Burlington Design Advisory Board

Design Advisory Board

Tuesday, March 17, 2026, 3:00 PM

To: The Design Advisory Board
From: Mary O’Neil, AICP, Principal Planner
RE: ZP-26-12
Location: 436 Riverside Avenue
Date: March 17, 2026

NORTH ELEVATION - BLDG. A
Scale: 1" = 20'

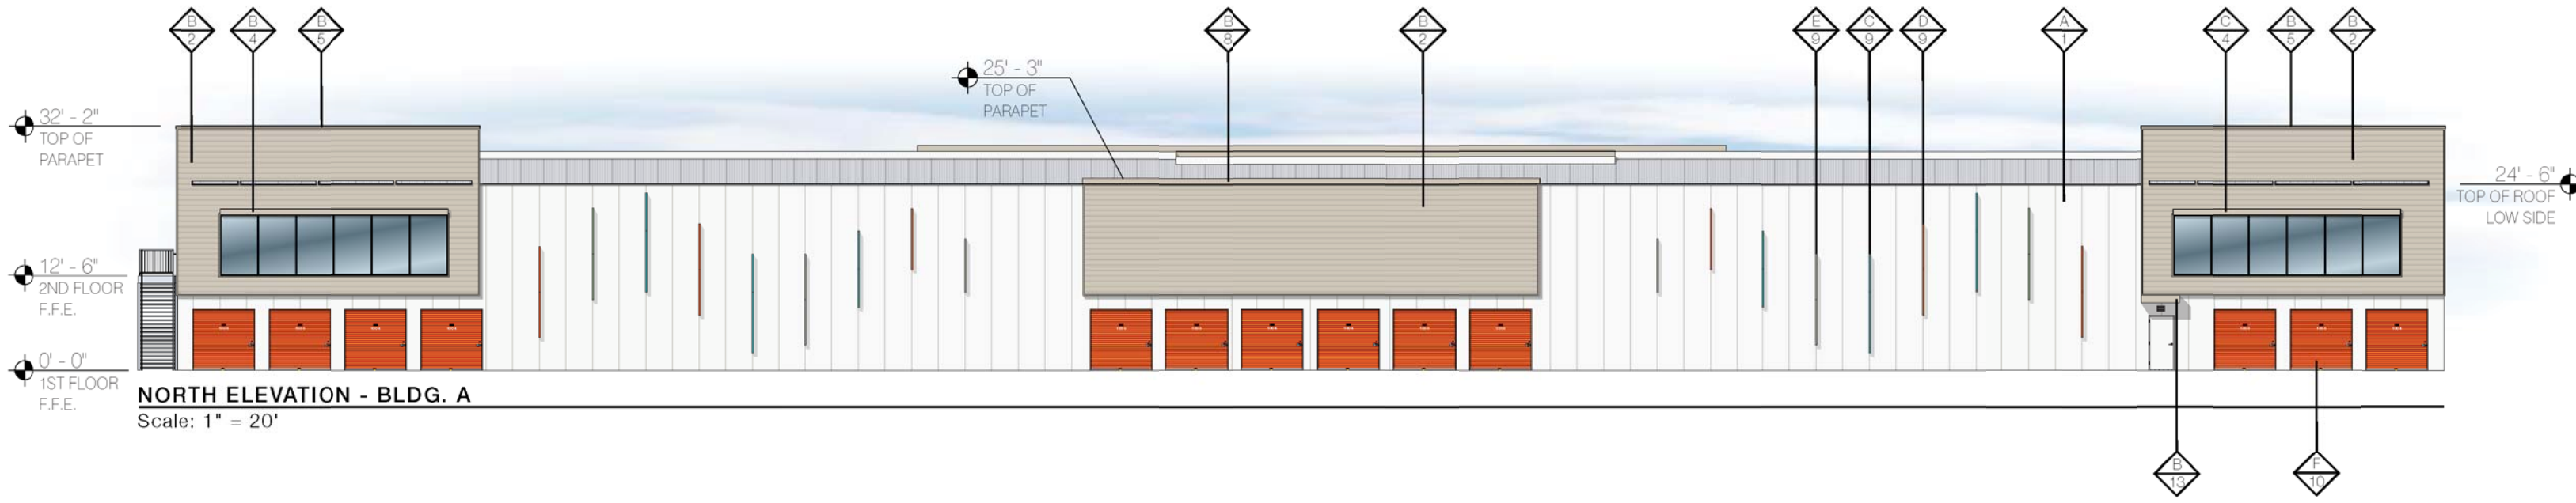
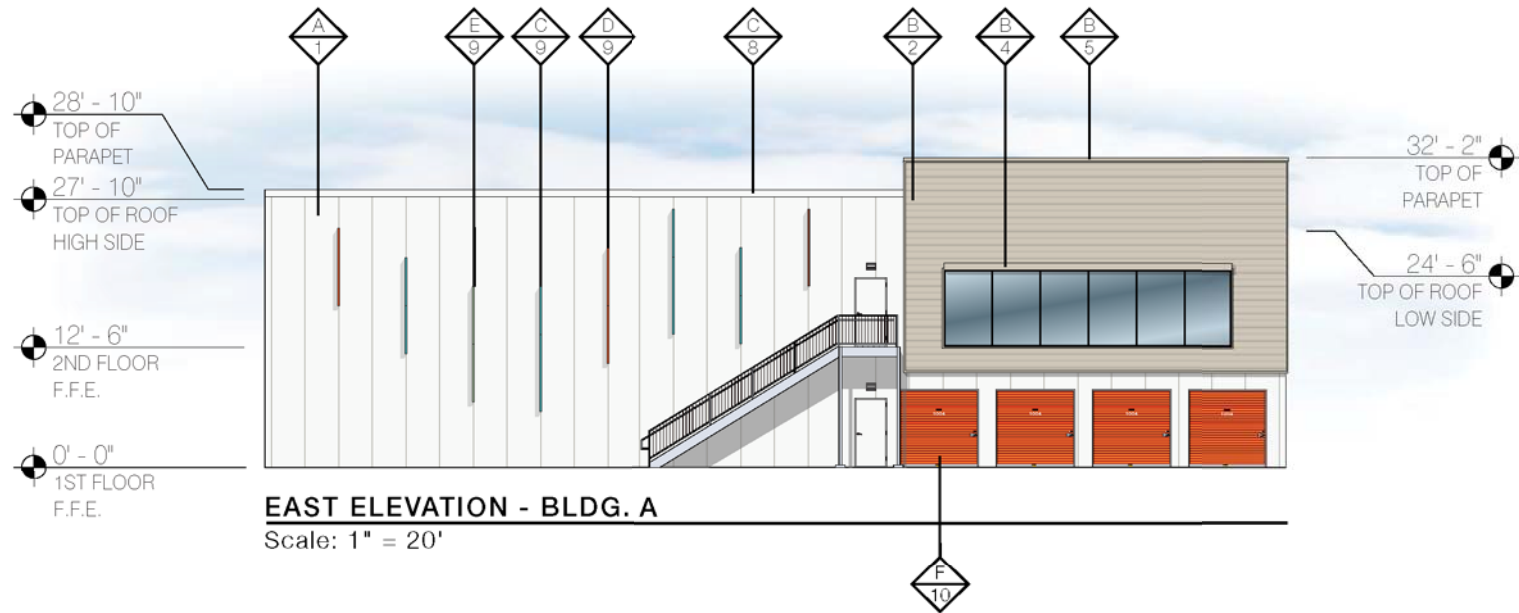
Design efforts, with differing materials, colors and building articulation break up the massing of the structure and present differing volumes to the streetscape. Revised elevations were uploaded February 25, 2026.

A flat roof is proposed, consistent with other manufacturing/warehouse/commercial buildings on Riverside Avenue. Revised plans have removed the undulating parapet and toned down the contrasting materials.

Elevation sheets define the intended use of insulated metal panels (IMP) with metal trim and a metal awning. See revised elevations on Sheets 1-4 for further details.

FIRST FLOOR PLAN
 SCALE: 1/4" = 1'-0"

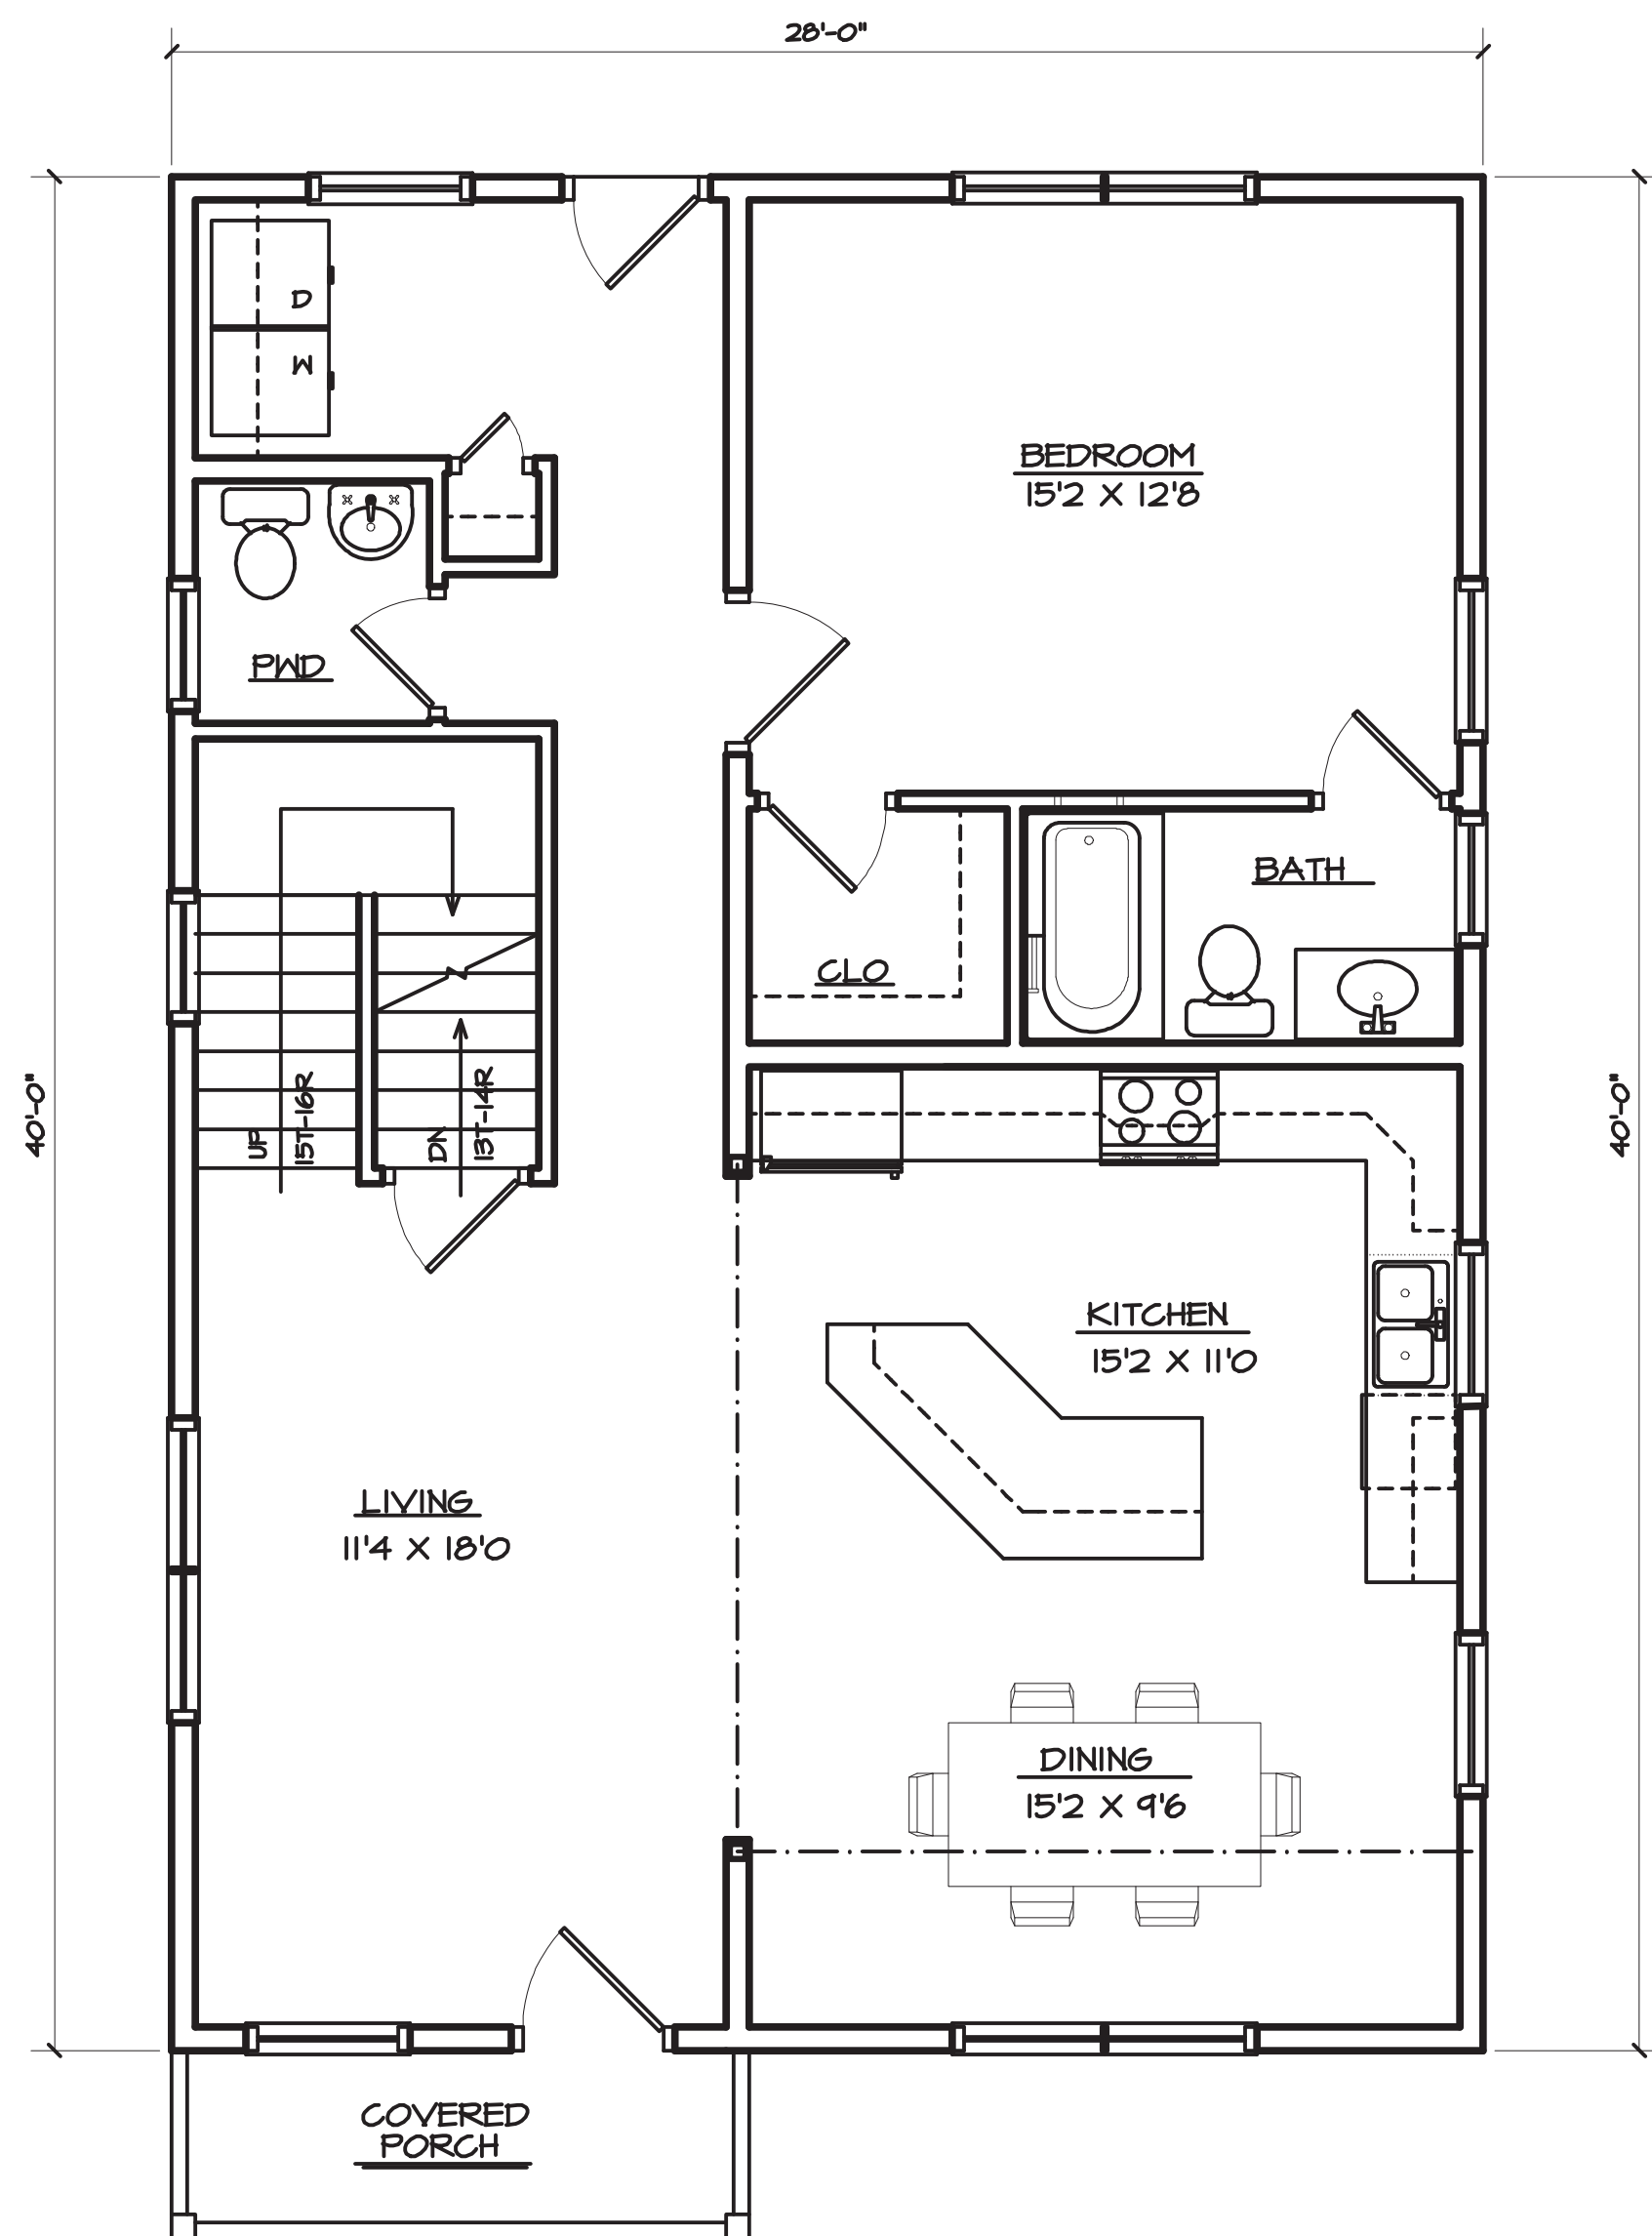
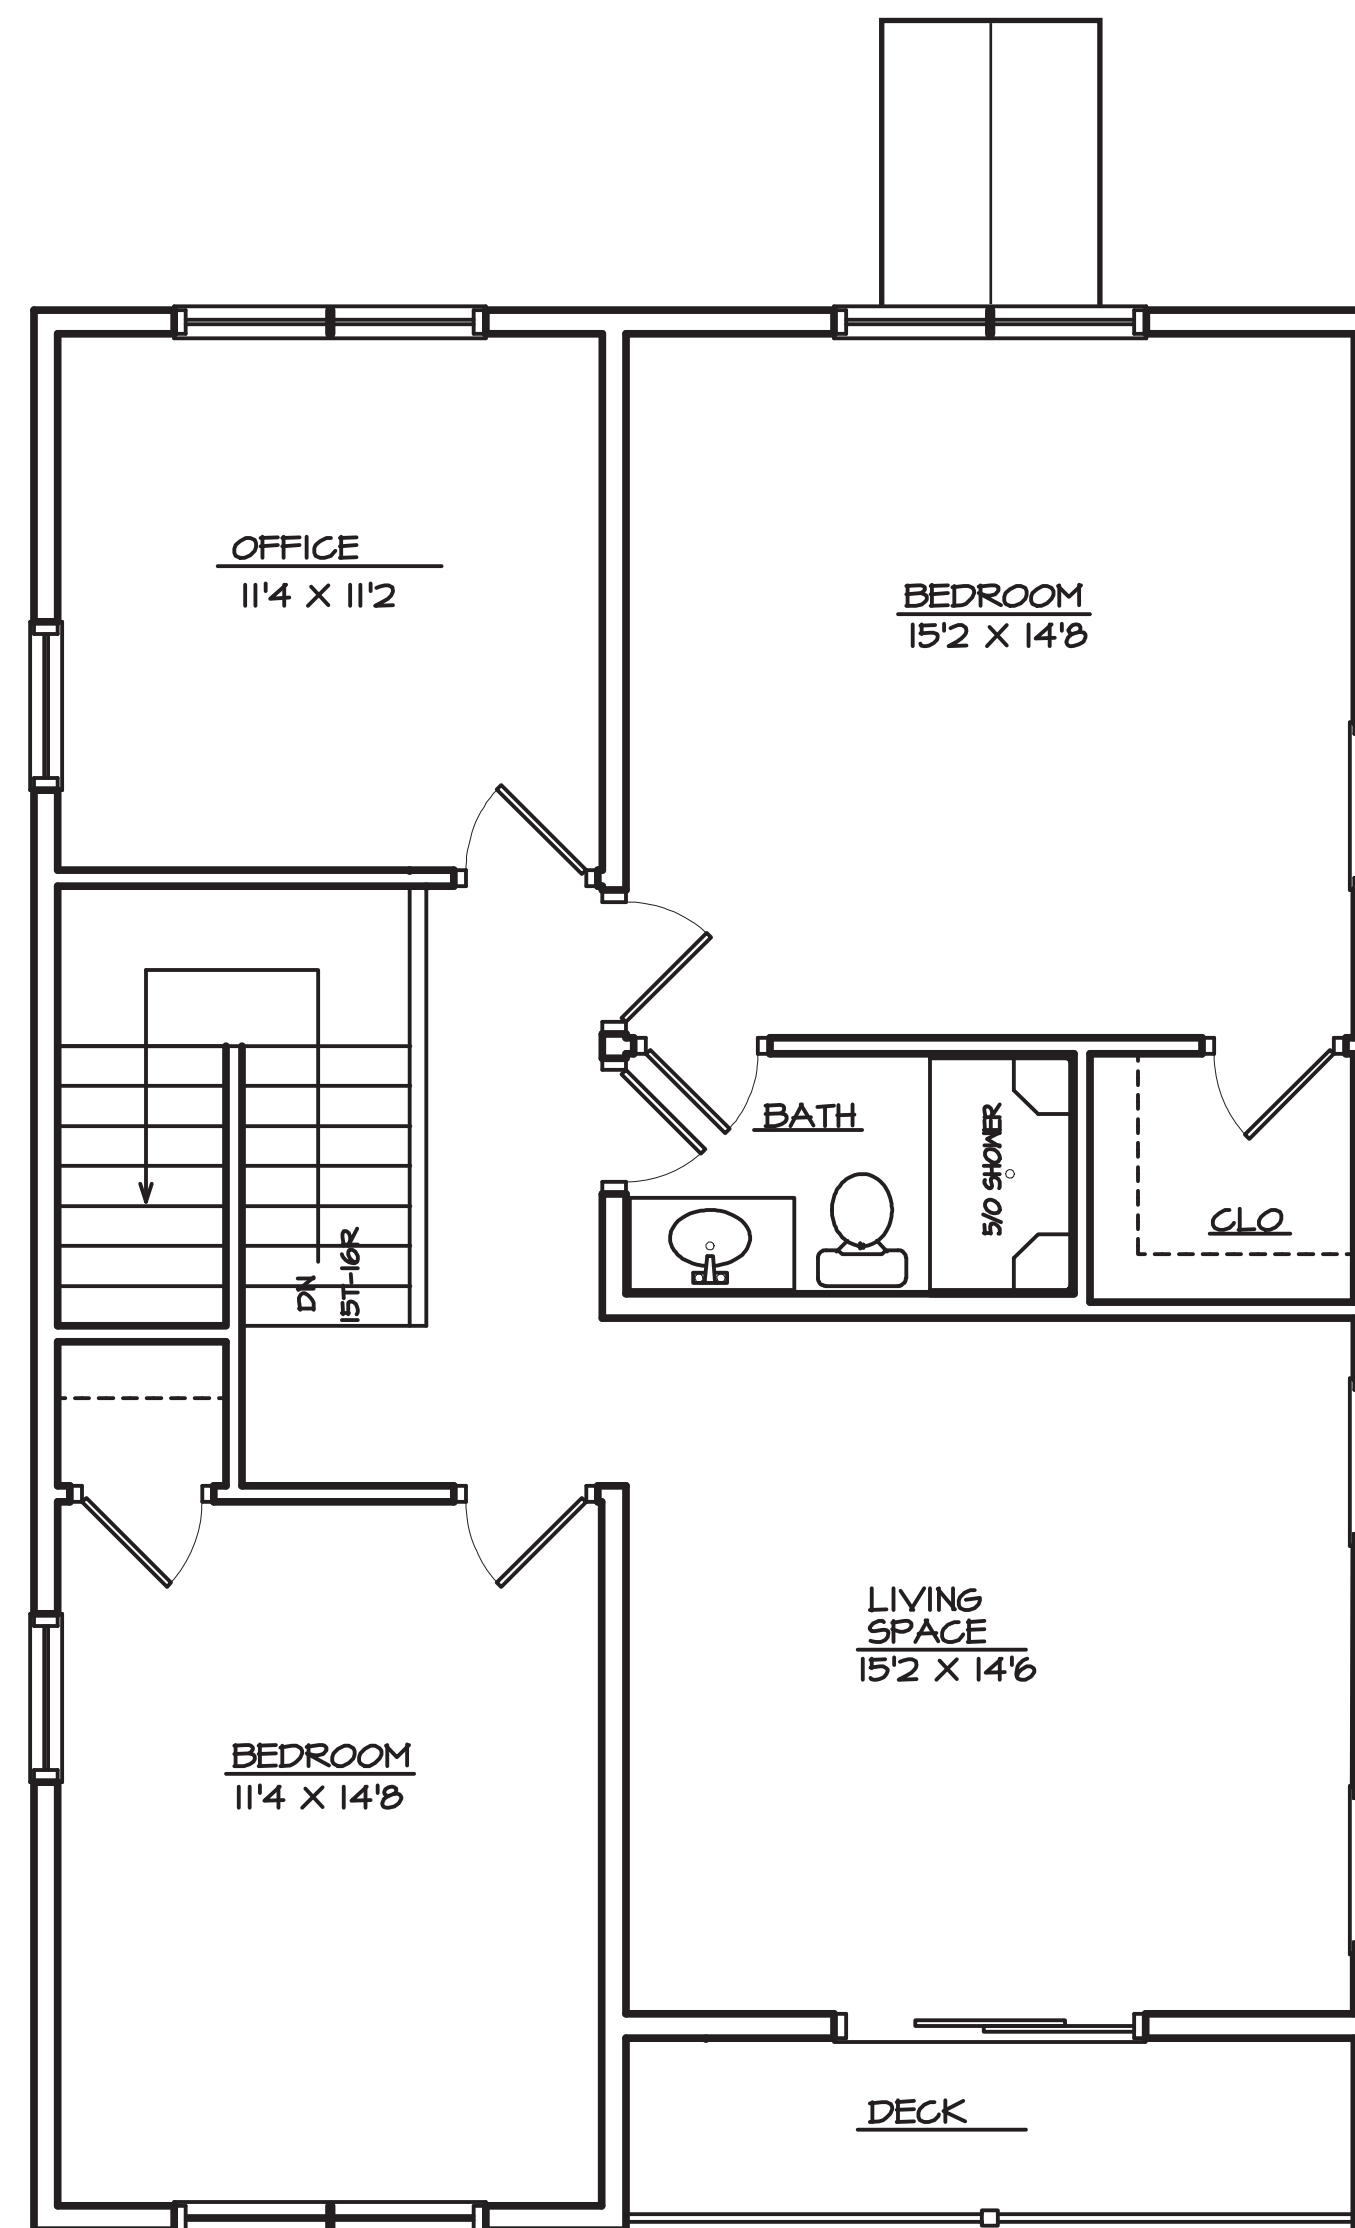
A covered porch on the principal structure will provide an element of shelter for residents from inclement weather. For the same reason, a canopy over the entrance to the ADU is recommended.

If the ADU is being utilized, a pedestrian walkway shall be identified between the public sidewalk and the building entrance.

1. A canopy is recommended at the entrance to the ADU.
2. A curb cut permit will be required from the Department of Public Works.

3. For access to the ADU, a pedestrian walkway needs to be identified between the public sidewalk and the rear structure.
4. This project is subject to Burlington's Thermal Heating Ordinance.
